**Churchill High School Backstop Netting Project
C.I.P. # 420.678.103**

ADDENDUM No. 1
April 9, 2018

Churchill HS Backstop Netting Project • 4j C.I.P # 420.678.103. Bid Documents dated March 28, 2018:

SITE PLAN

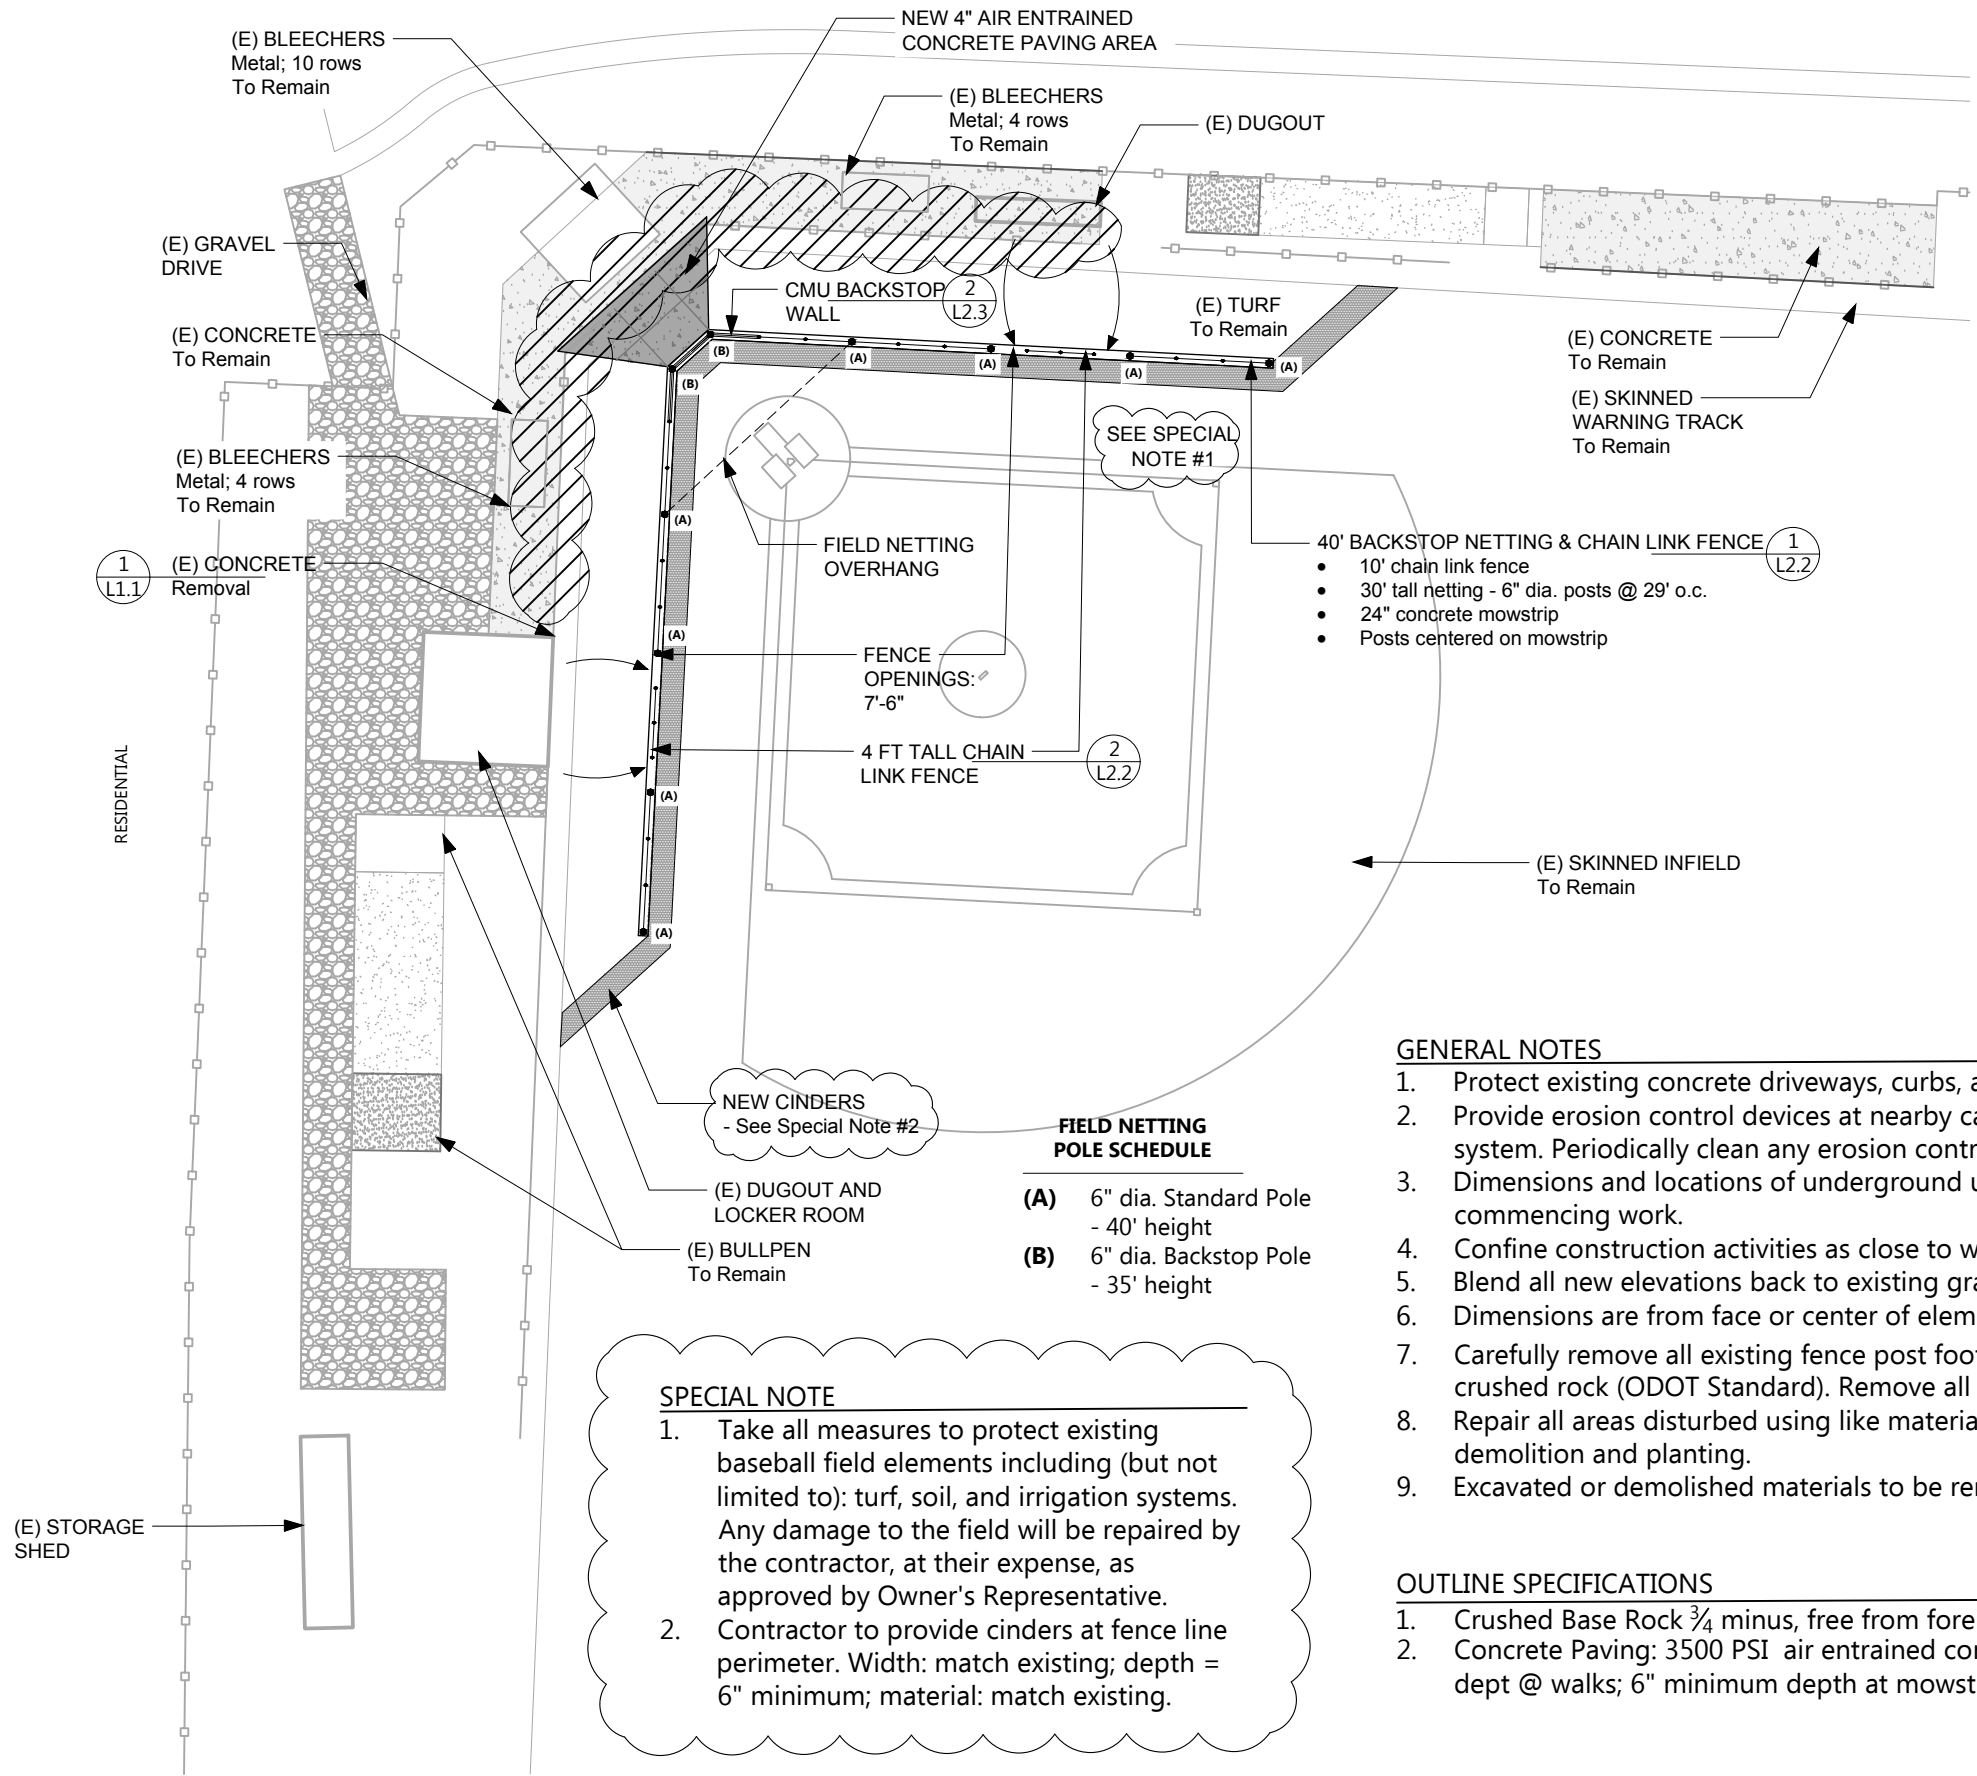
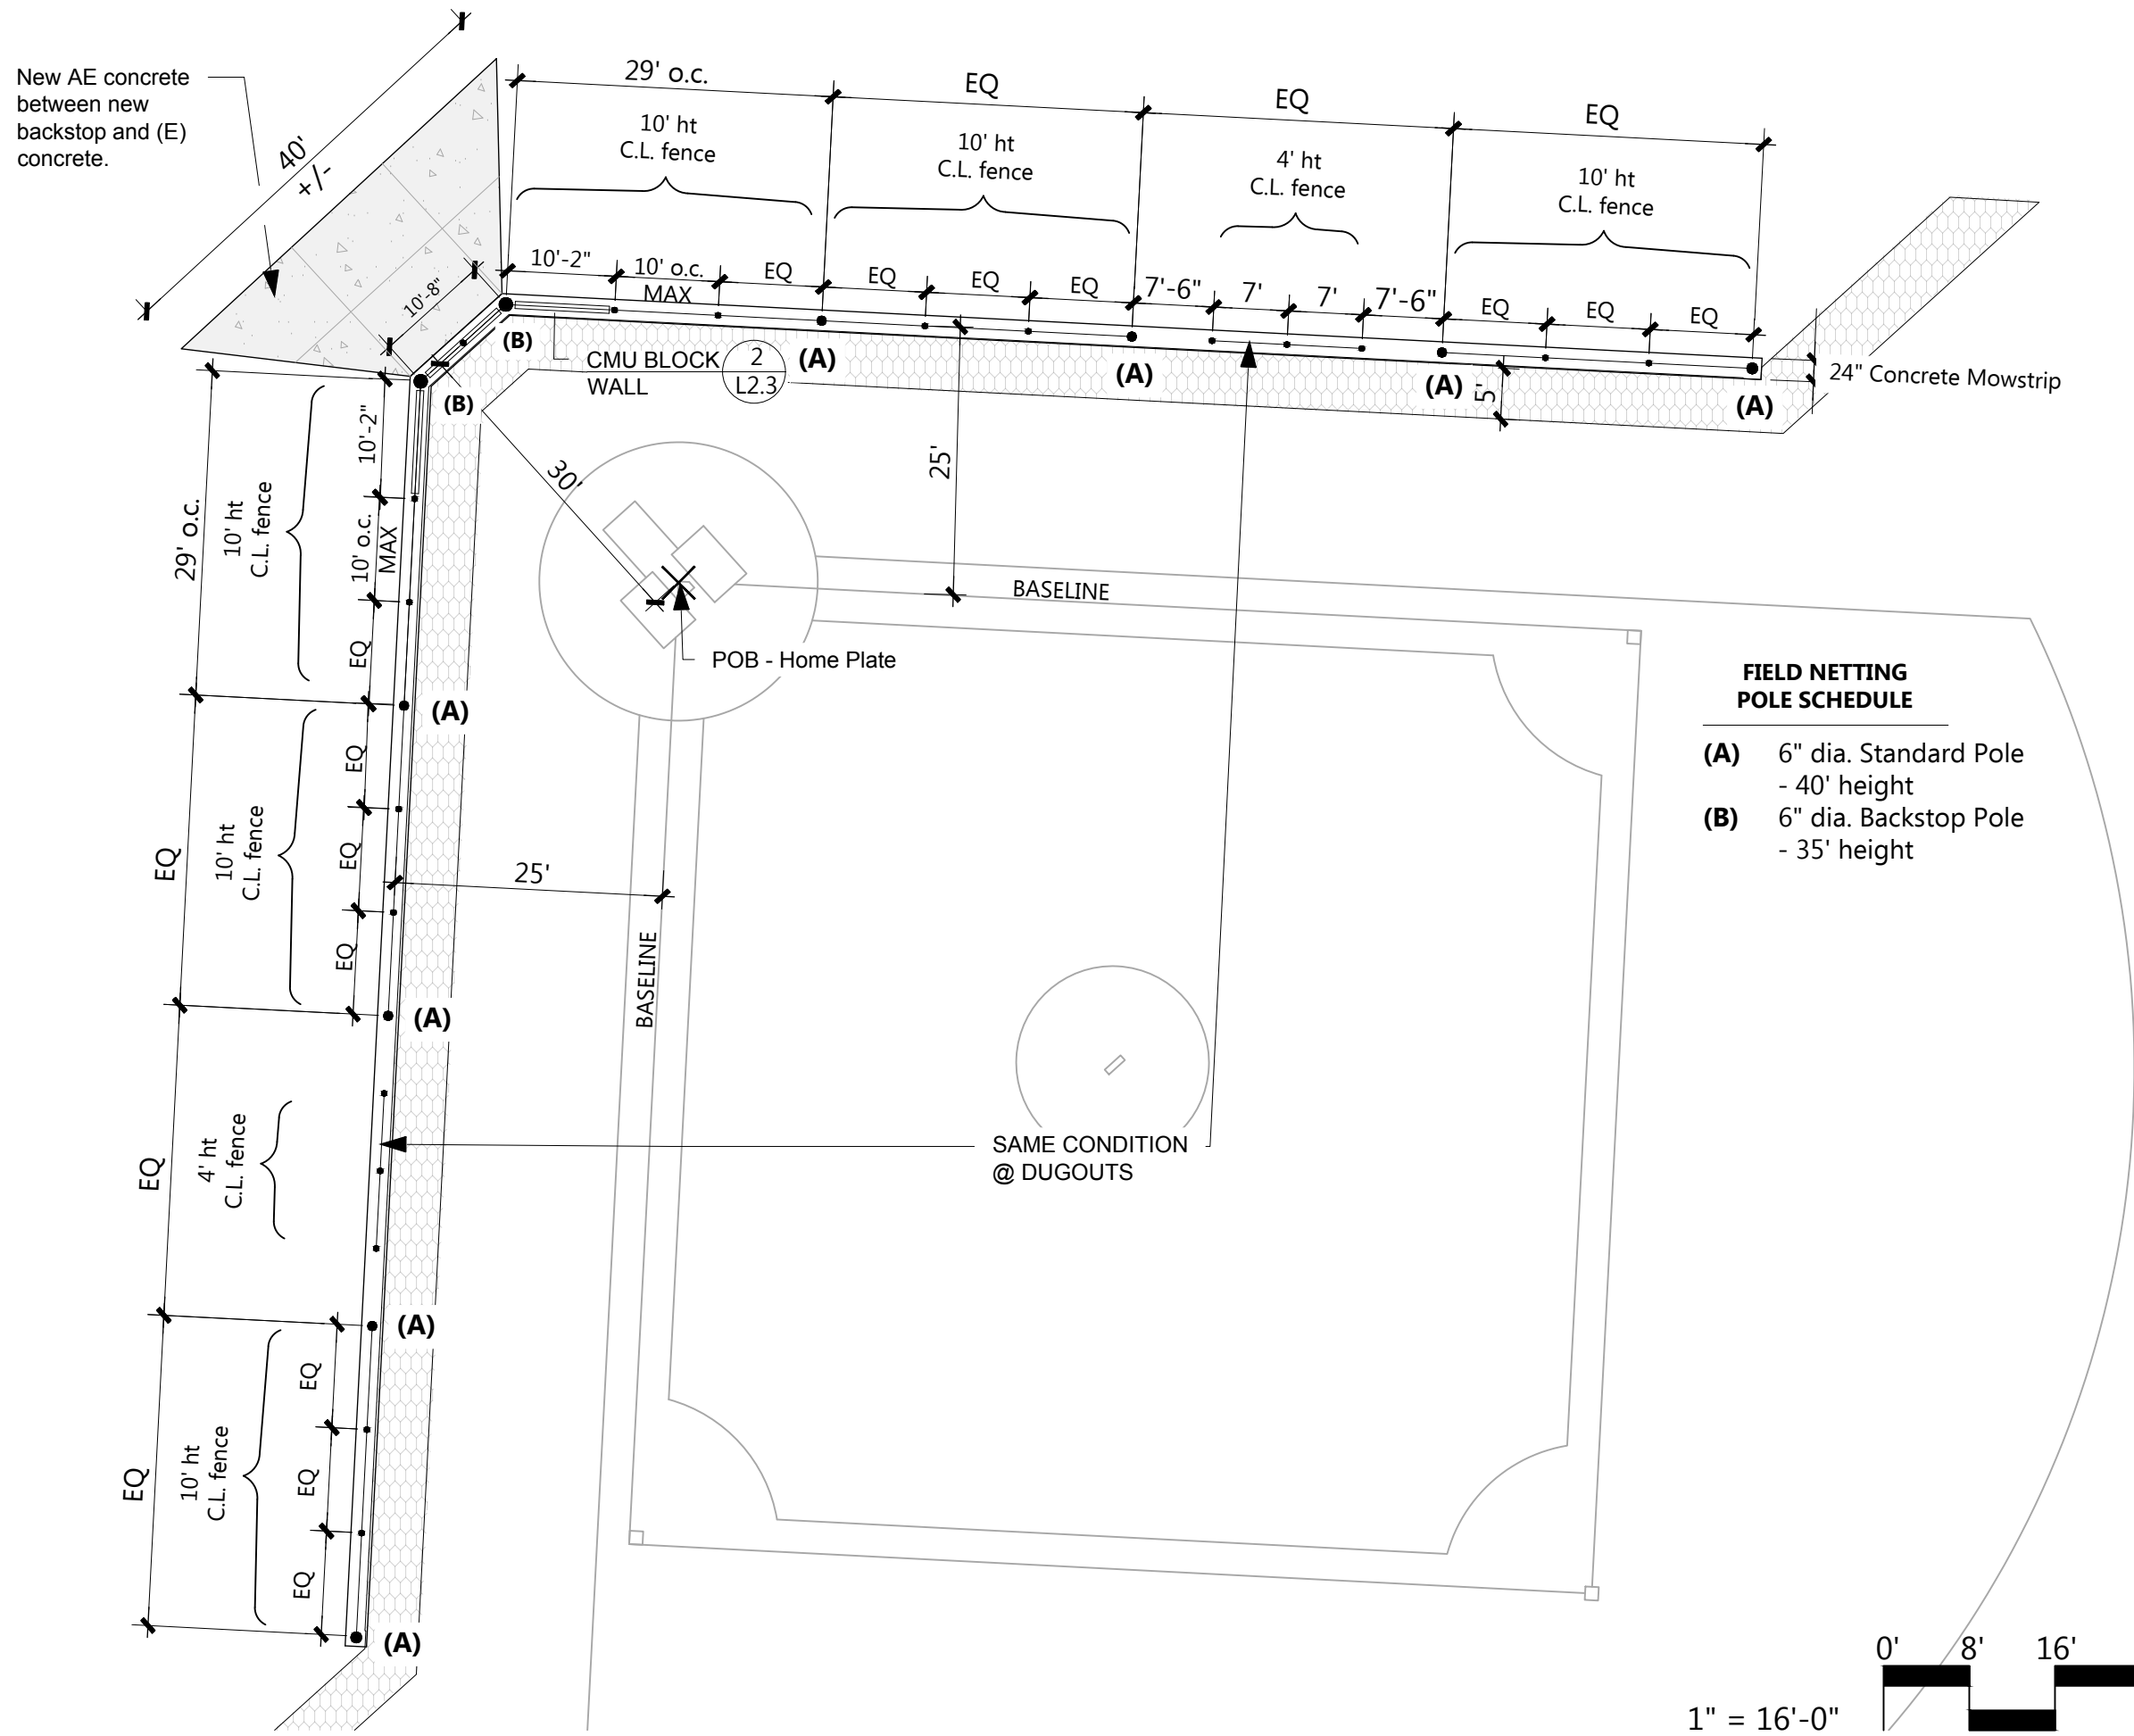
3. Replace Drawing – Sheet L1.1 – Site Plan attached to this Addendum. **Clarification:** Revised Site Plan includes changes to the netting poles sizes and Special Notes regarding baseball field protection and cinders to be provided by Contractor.

(A)	6" dia. Standard Pole - 40' height
(B)	6" dia. Backstop Pole - 35' height

CMU WALL w/ FENCE
@ Backstop

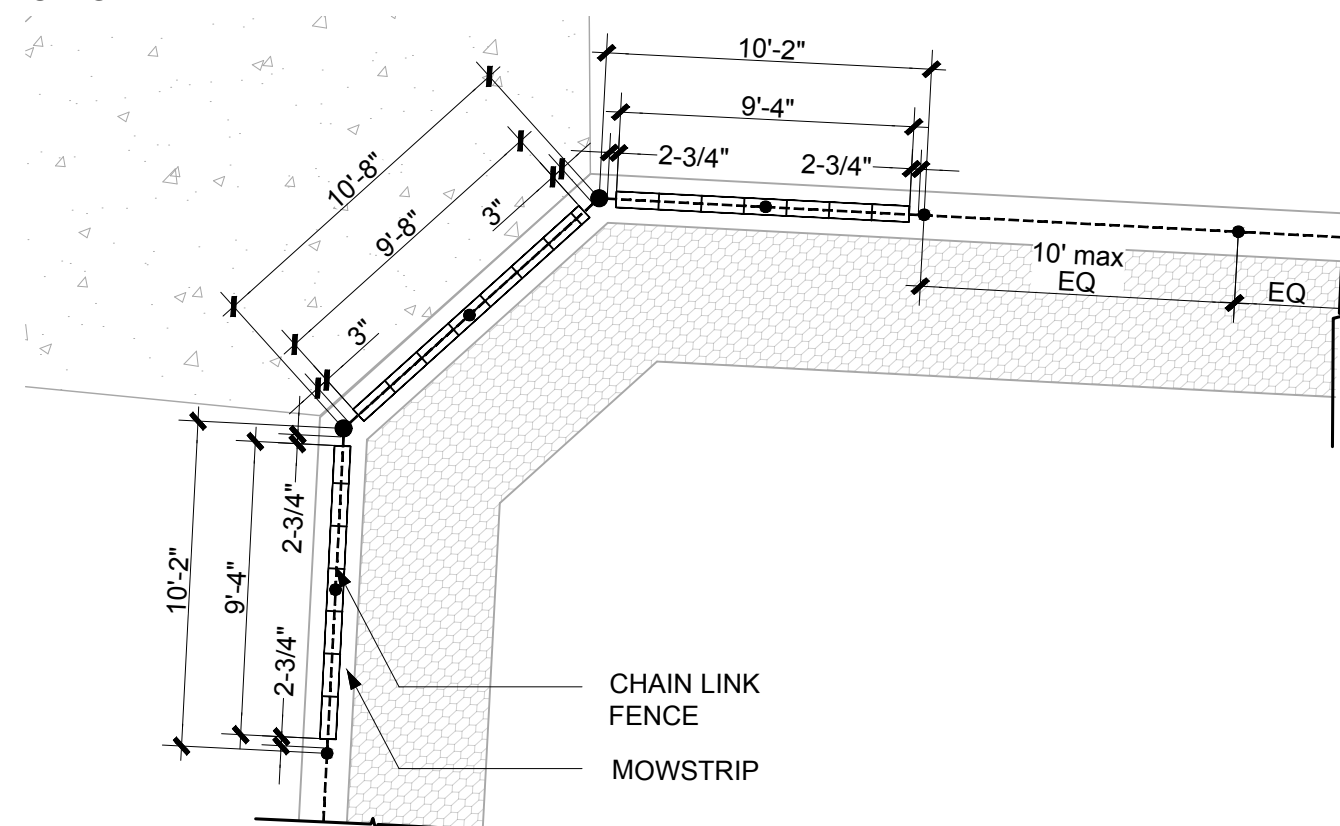
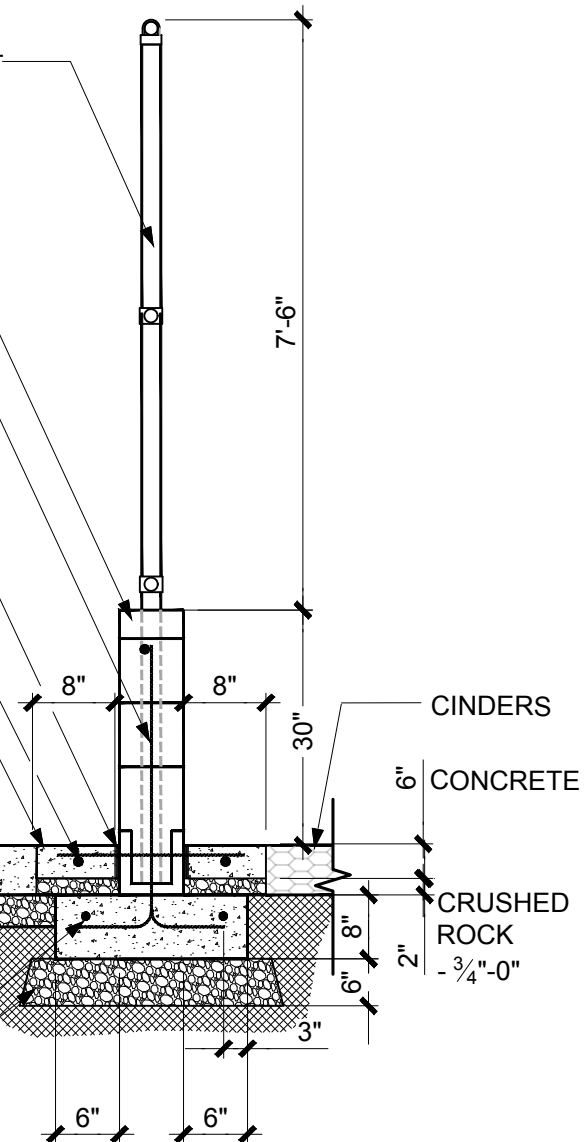
6. The Contractor has the option to install a formed, CIP concrete wall in lieu of a CMU wall as shown on Sheet L2.3. The Contractor must receive approval of this approach, including wall final dimensions, wall finish etc. prior to commencing work.

1. Running bond pattern.
2. CMU Wall to utilize following or similar products:
 - 2.1. FULL BLOCK: Willamette Graystone (8x8x16): 800 B
 - 2.2. CAP BLOCK: Willamette Graystone (8x3x16): 400 S
3. CONTRACTOR'S OPTION: Contractor may install cast-in-place formed concrete wall in lieu of CMU wall. Wall could enclose entire net poles.
